MEMORANDUM

TO: Mayor and City Council
VIA: Tanisha Briley, City Manager
FROM: Dennis Enslinger, Deputy City Manager
Rob Robinson, Long Range Planning Manager
RE: Lakeforest Public Hearing – Follow-up Items
DATE: March 7, 2023

During the Joint Public Hearing on the Lakeforest Rezoning and Sketch Plan, three items were brought up by the public: community facilities near Lakeforest; the potential of daylighting an 84-inch stormwater pipe; and the tree stand at the NE corner of Montgomery Village Avenue and Lost Knife Road. The Mayor and City Council requested staff provided more background before the policy discussion. Below is a brief discussion of each of the items that take into account the applicant’s responses, which can be found in more detail at the following link:

PIPE DAYLIGHT EXHIBIT 2

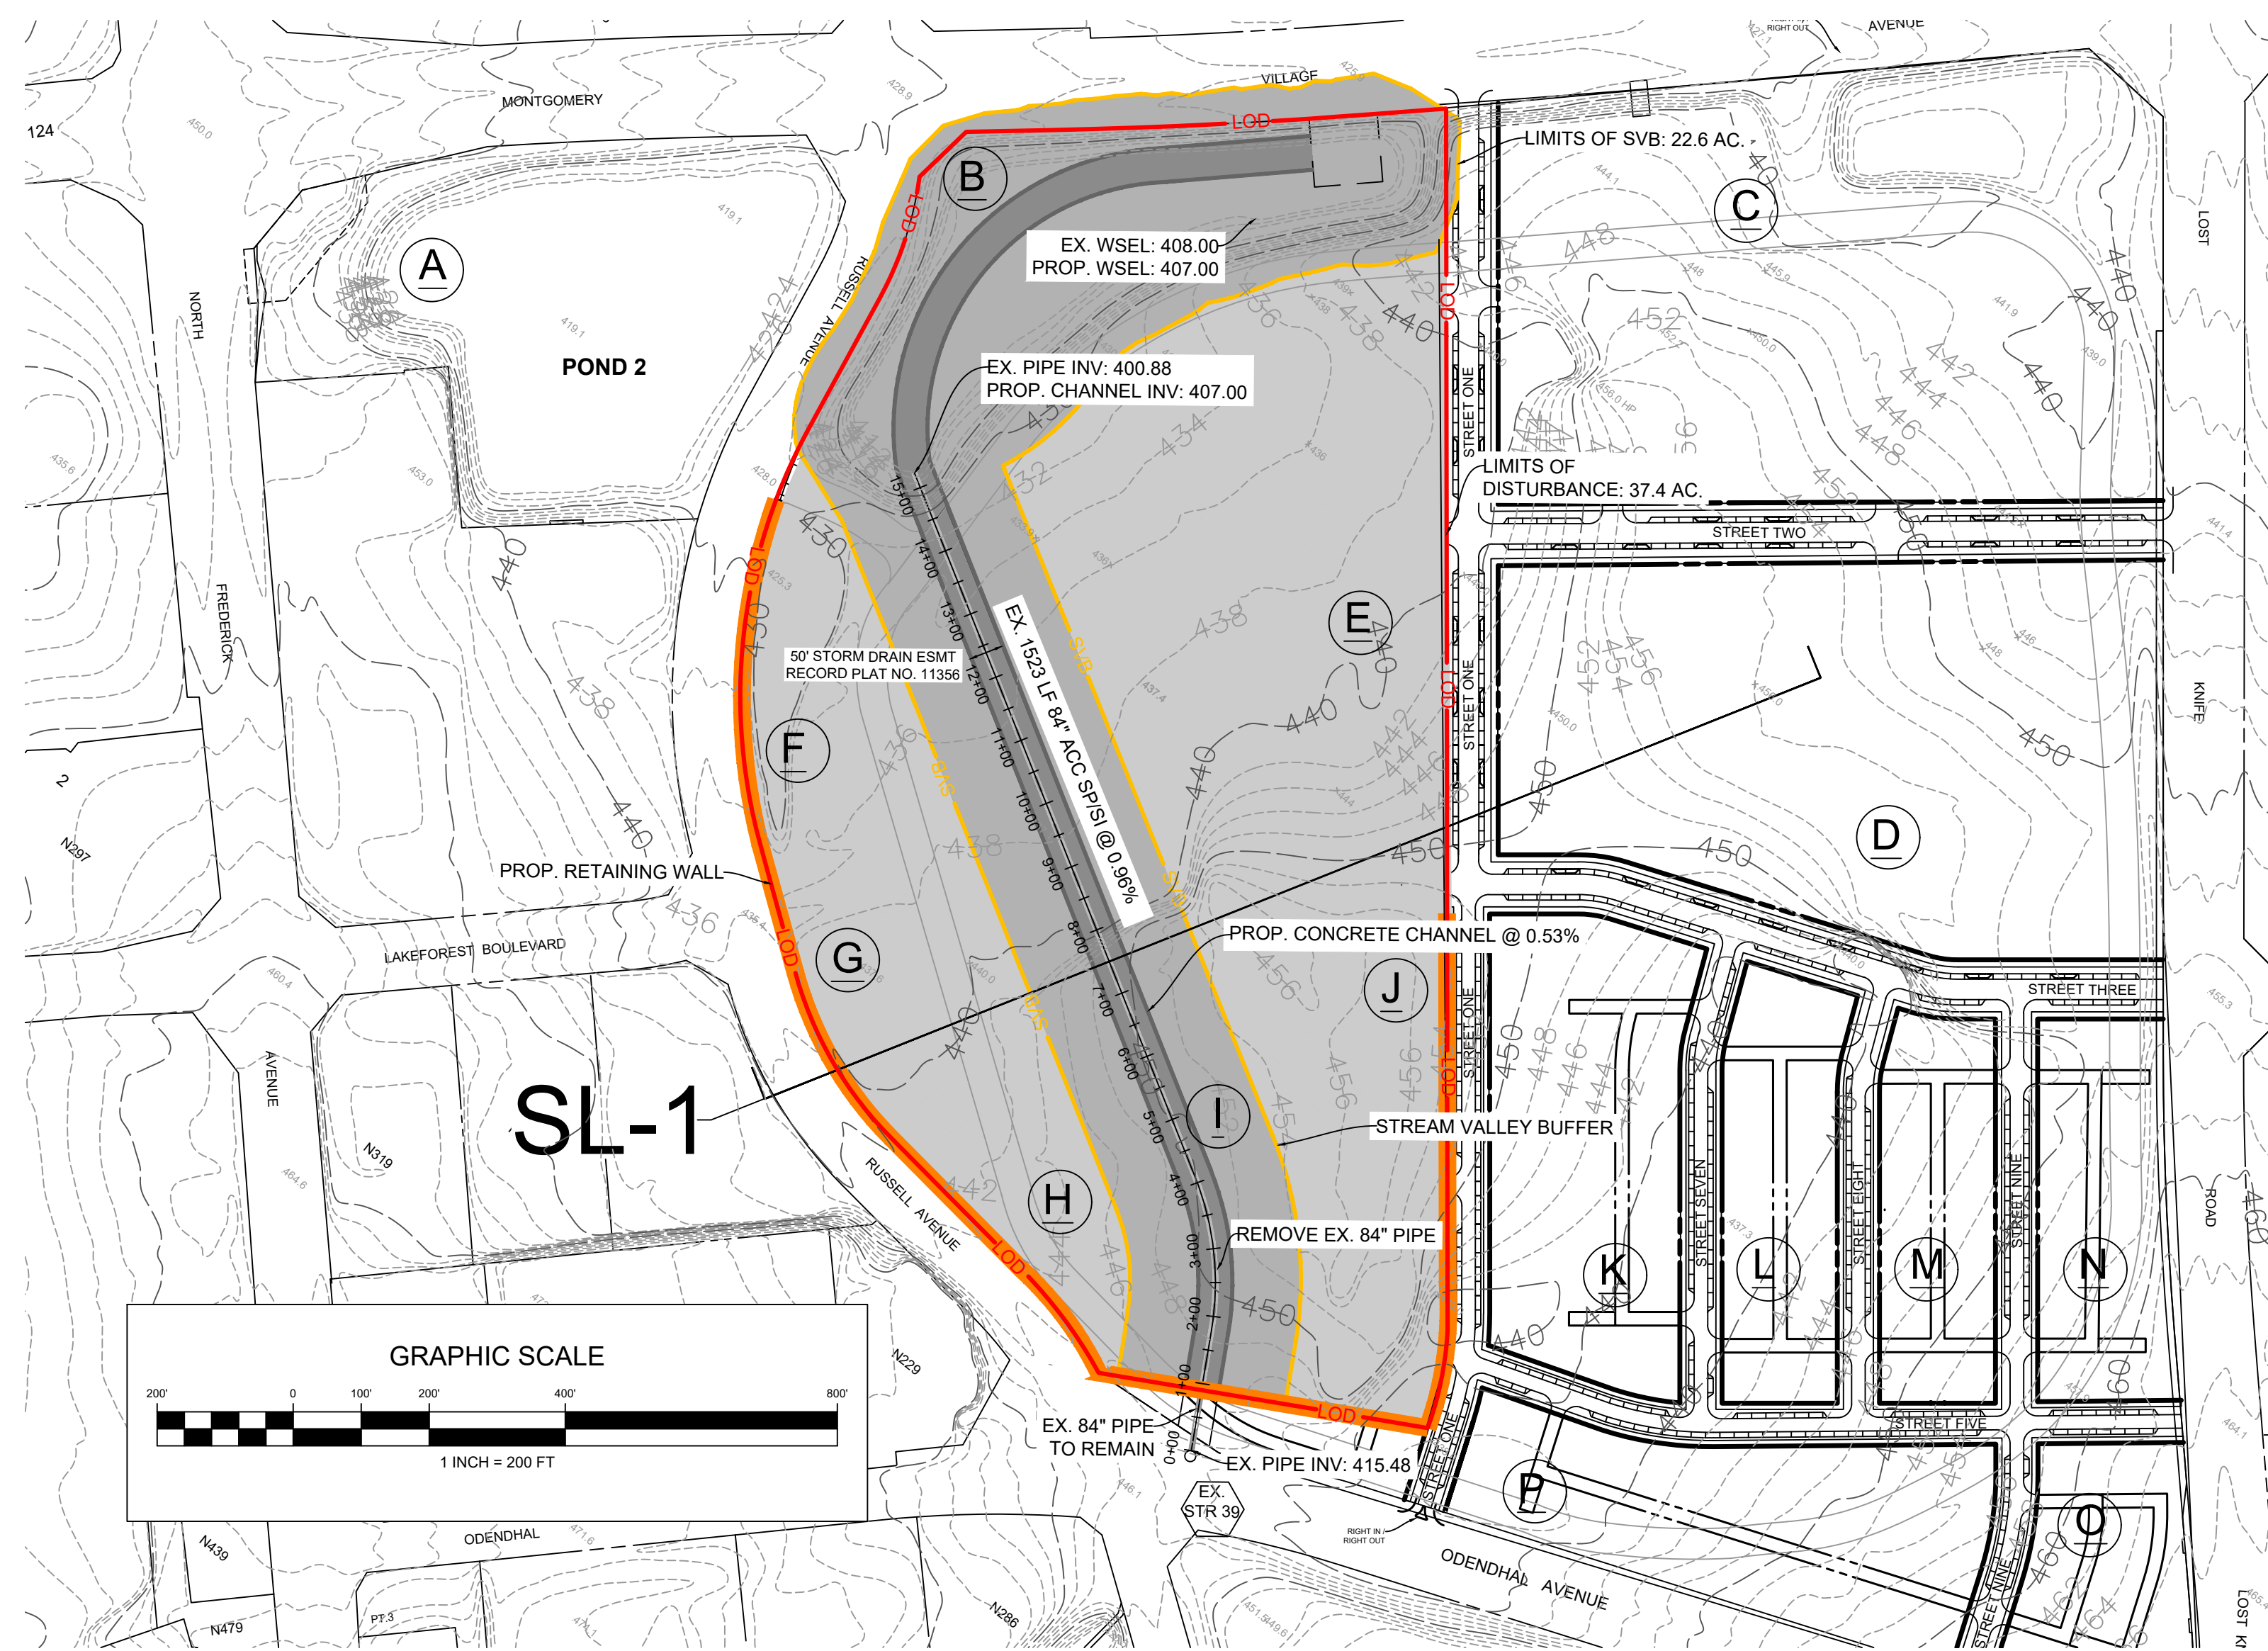
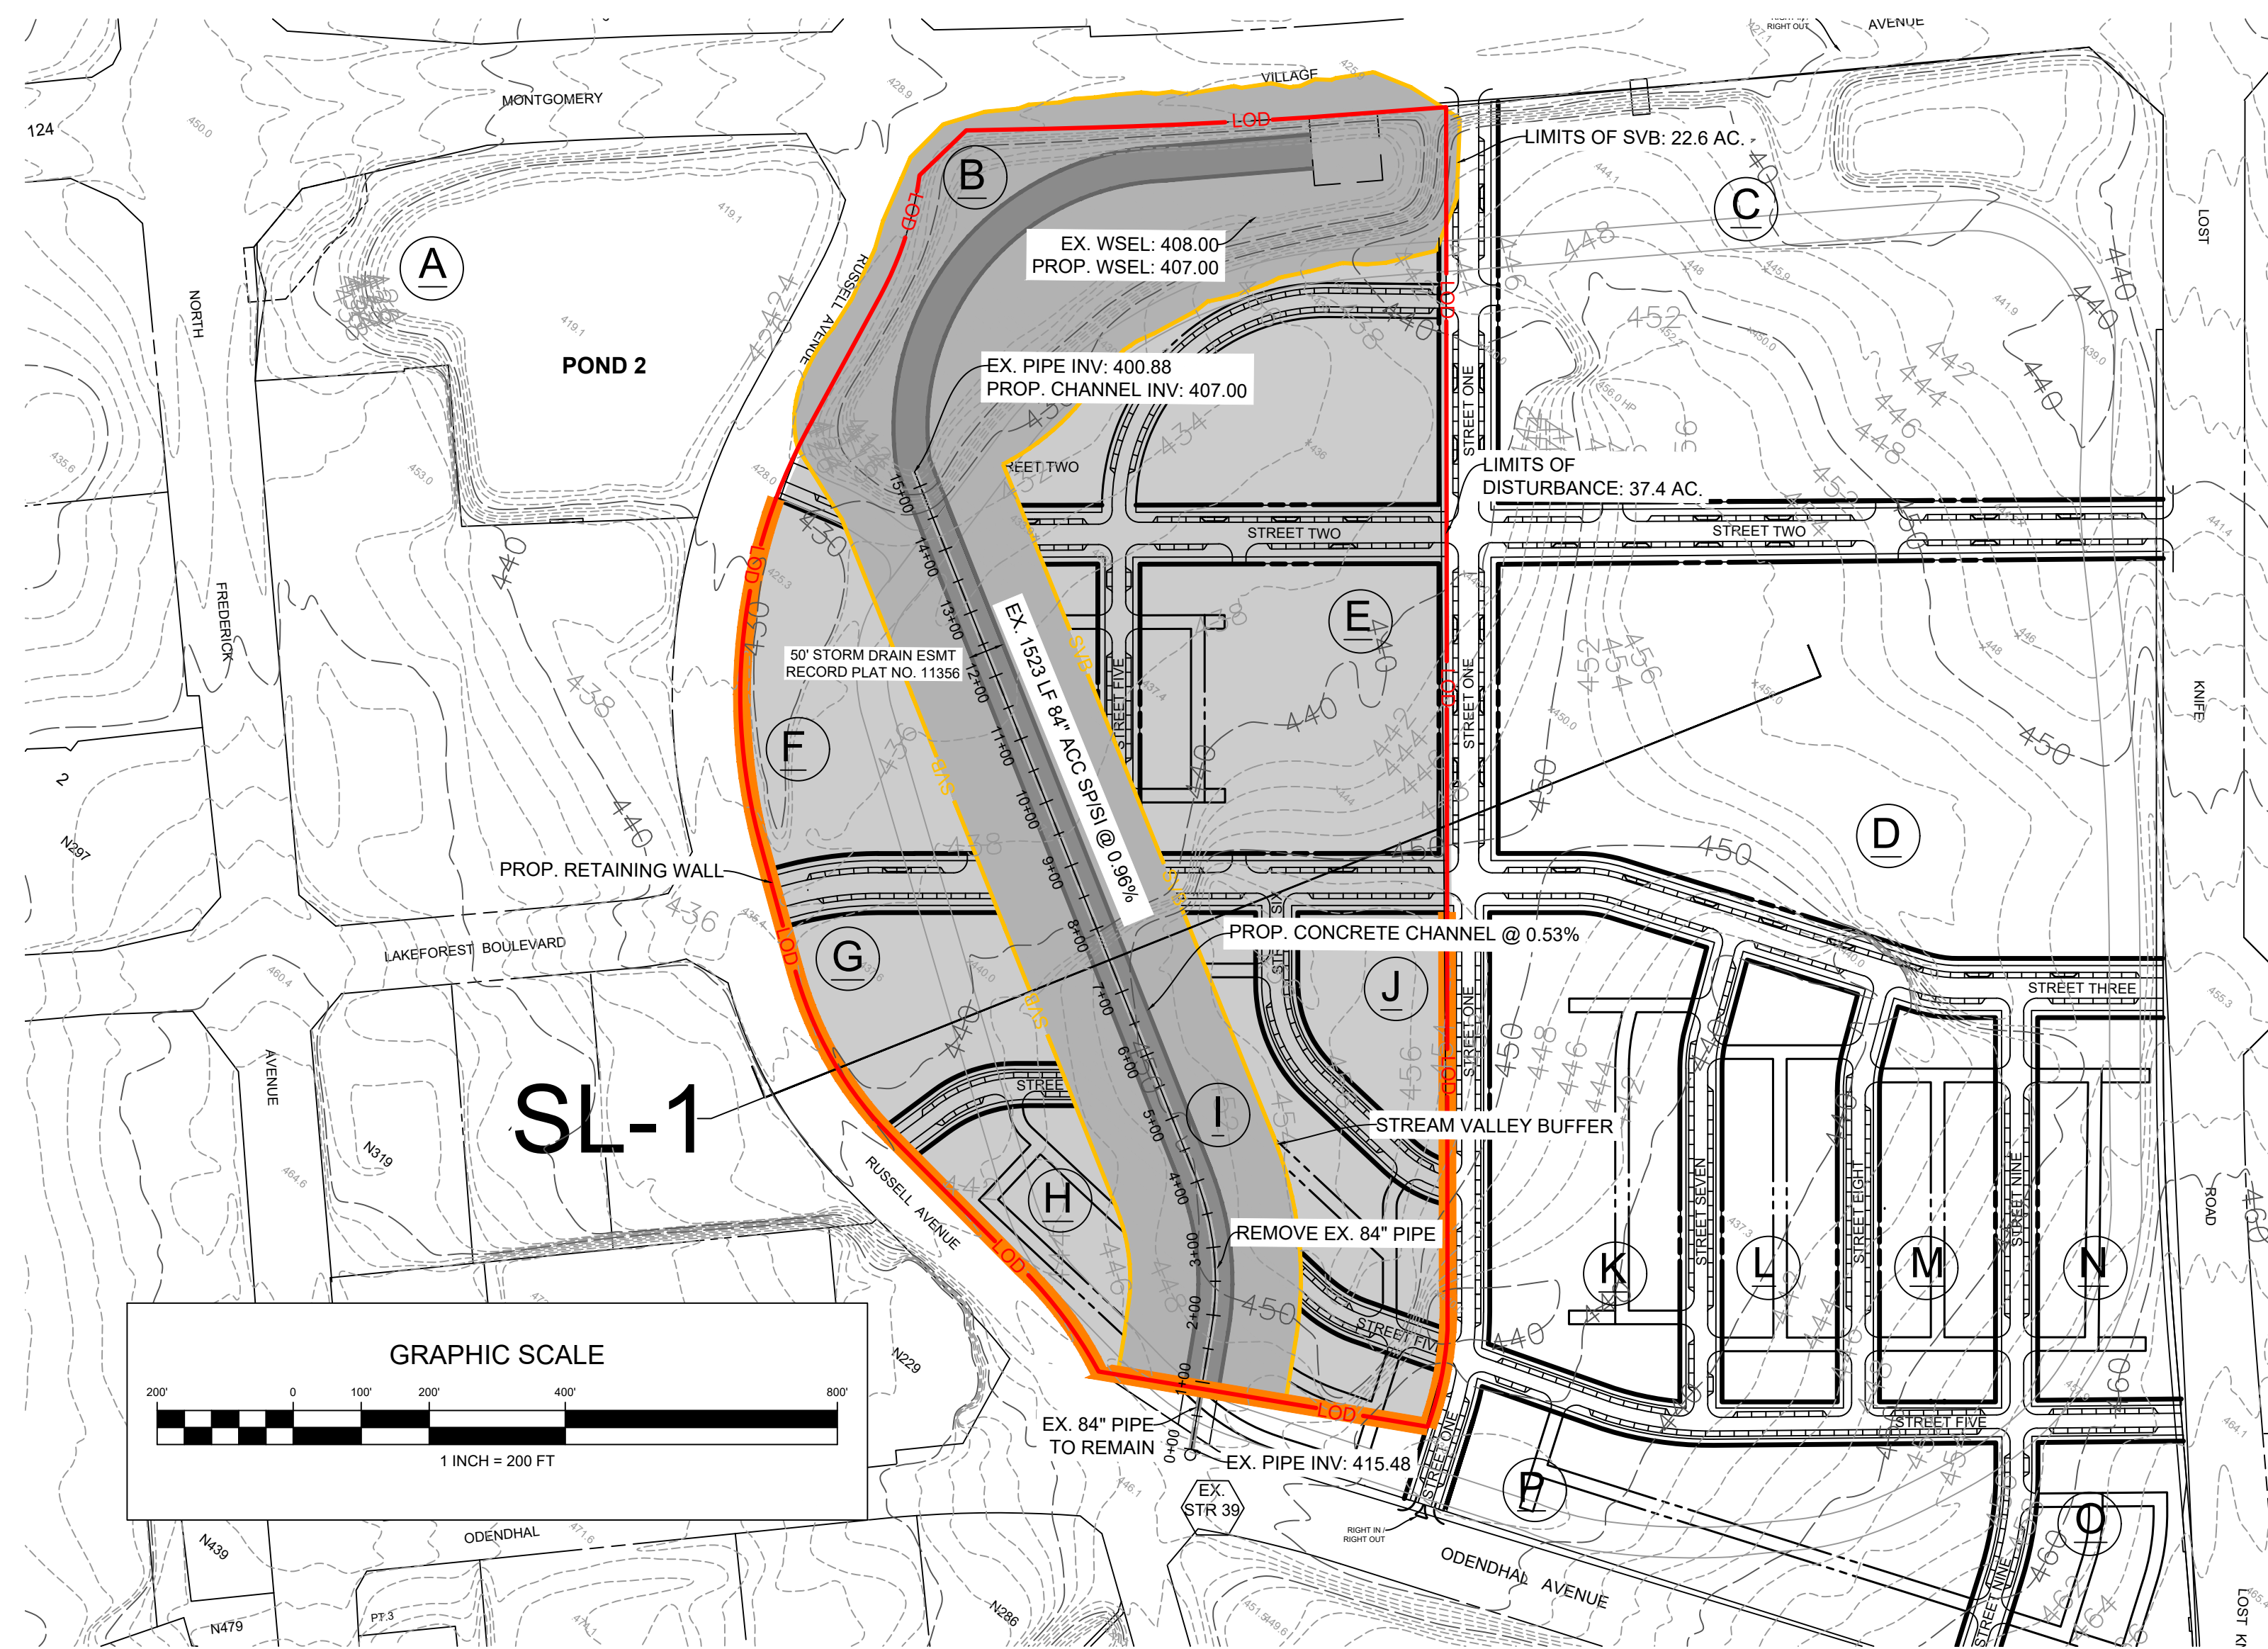
Attachment 2 (Exhibit 2 provided by developer) shows a scenario that reflects a more realistic daylighted stream based on existing conditions. Under the developer’s scenario to accomplish daylighting a pipe 30’ below grade, approximately 37 acres of the developable 75 will be needed to lower the site, provide appropriate side slopes, stream valley buffer, floodplain and floodplain building restriction lines, retaining walls, etc. to make this work. The developer further states that the ‘stream valley’ blocks B, E, F, G, H, I, and J will be eliminated. The east-west roads would not connect.

In reviewing the scenario presented by the developer, stormwater staff has noted that other alignments may provide less of an impact on the overall design. The example alignment increases the impact to the proposed development project and amplifies the depth issue. However, daylighting the stream would certainly impact the site and be a costly endeavor under the best-case scenario,.

While there may be ways to reduce the acreage required to daylight the stream, it is clear that the amount of acreage needed would significantly impact the ability of the developer and the community’s ability to realize the Master Plan and its recommendations. It is clear that daylighting the stream would require reductions in the overall density and potential uses on site due to the loss of developable land. Additionally, it would be difficult to achieve the connected roadway networks (as recommended in the plan) without significant long-term infrastructure maintenance costs, which would ultimately be the responsibility of the public at large.

Staff agrees that, while the possible daylighting of the 84-inch pipe could create a dramatic stream valley park, it would also render the project economically infeasible - not just from the cost side, but from the reduced development capacity perspective. Planning staff does not support daylighting the storm pipe and is concerned that any such requirement will curtail Master Plan envisioned redevelopment and result in continued C-2 Zoning and vested operations.
